The Pipeline

Melbourne Retail Water Agencies Information Bulletin

Issue Date – December 2016

WELCOME TO THE NEW MRWA BULLETIN

FIGURE 104A-C: OPTION C EXAMPLE- RESTRAINED LOW SHRINKAGE PIPEWORK

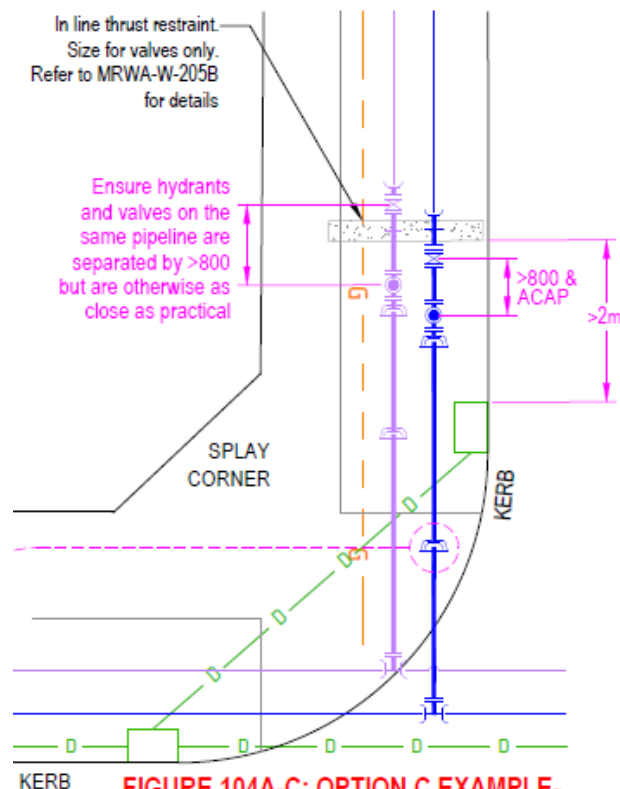
- **MRWA-W-104A- Pipeline Restraint Options & Fitting Arrangements.**
Pipeline systems have now been separated into 3

systems: Rubber Ring Joint, restrained high shrinkage (PE) and restrained low shrinkage. PE is now to be the default pipe system for \leq DN355 pipes where restrained pipework is required. Requirements for the restraint of some doglegs is now included along with the requirements for the separation of fittings on single and dual water systems.

SOUTH EAST WATER CORPORATION
MAINTENANCE HOLE DRAWING APPENDIX
TRUNCATED TOP DETAILS

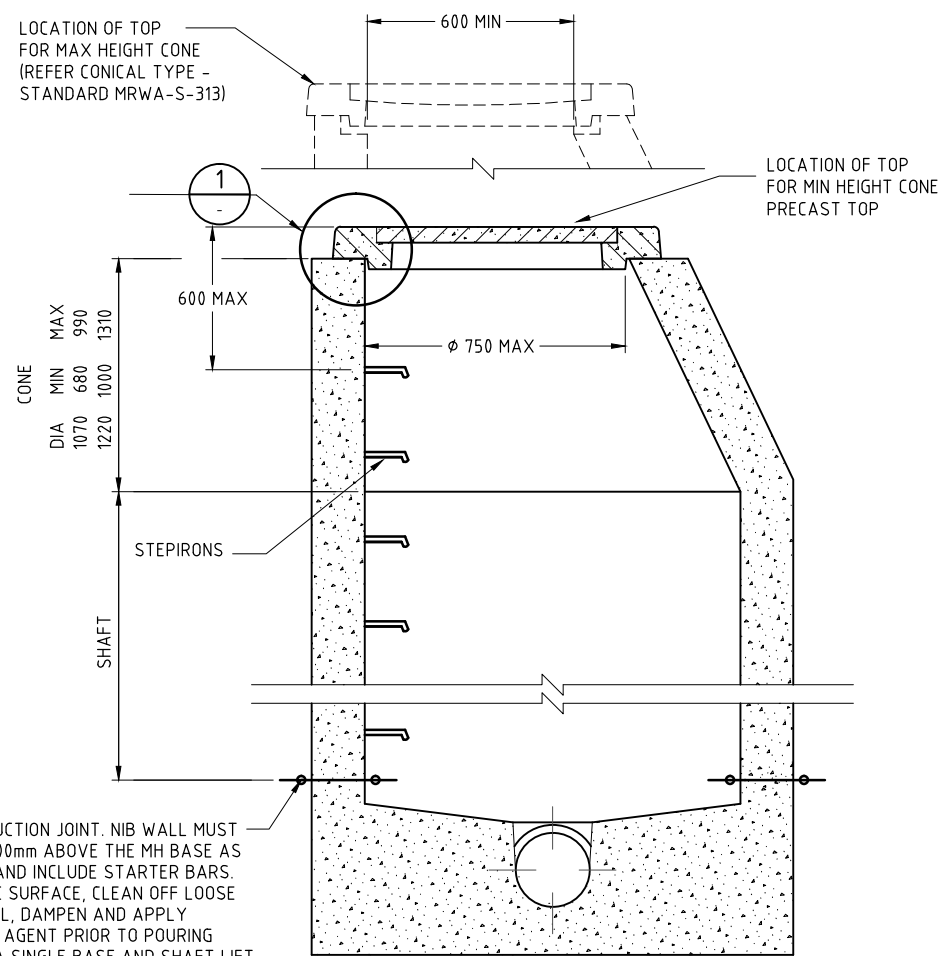
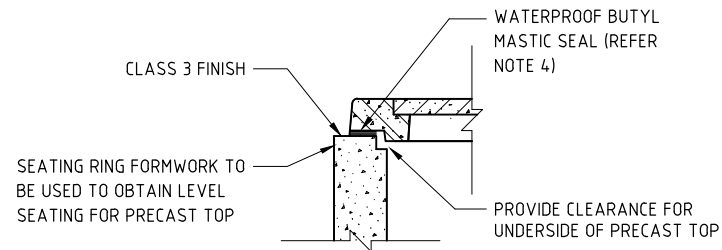
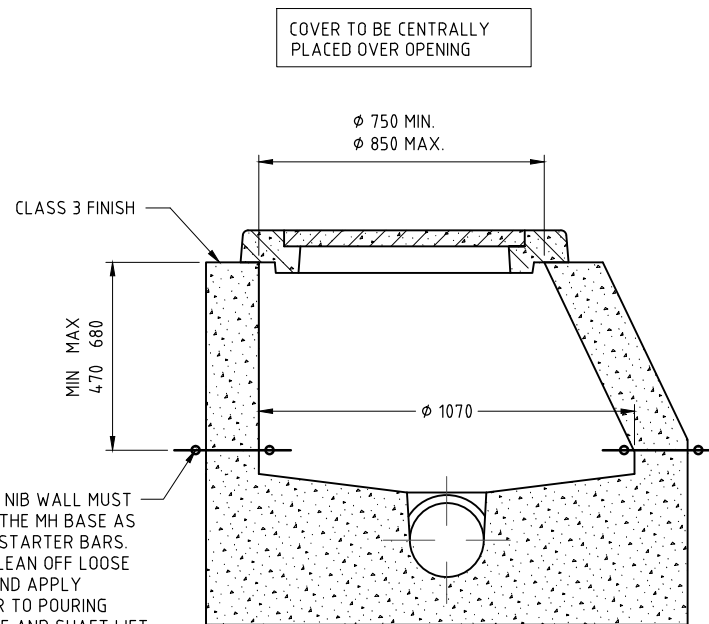
shallow reticulation sewers require a MH. Following a brief consultation period with industry stakeholders, the MRWAs will now allow the installation of Truncated top MHs as an alternative to the Flat-top arrangement for shallow reticulation sewers. These maintenance structure types were previously adopted in earlier Technical Standards and have been installed on shallow reticulation sewers for many decades.

Truncated MHs may be used as follows:

- For shallow reticulation sewers where the overall depth to the MH base nib wall is less than 2.0metres.
- In locations not subject to vehicular loading. (ie: not allowed in Type R situations (ref MRWA-S-201) or driveways).
- Where it is not practical or cost effective to install a smaller Maintenance Shaft or Maintenance Chamber structure.

The general arrangements for Truncated MHs are outlined in South East Water's MH Drawing MHTA-07 included as a drawing appendix with this bulletin. This information shall be read in conjunction with the 300 Series MRWA Sewer Standards and can now be installed on reticulation sewer projects where applicable. Flat-top MH arrangements can still be constructed for shallow MH structures where required and as described in MRWA Sewer Standard MRWA-S-313. This Drawing Appendix will remain current until the relevant MH Sewer Standards can be revised and published onto the MRWA Web Portal.
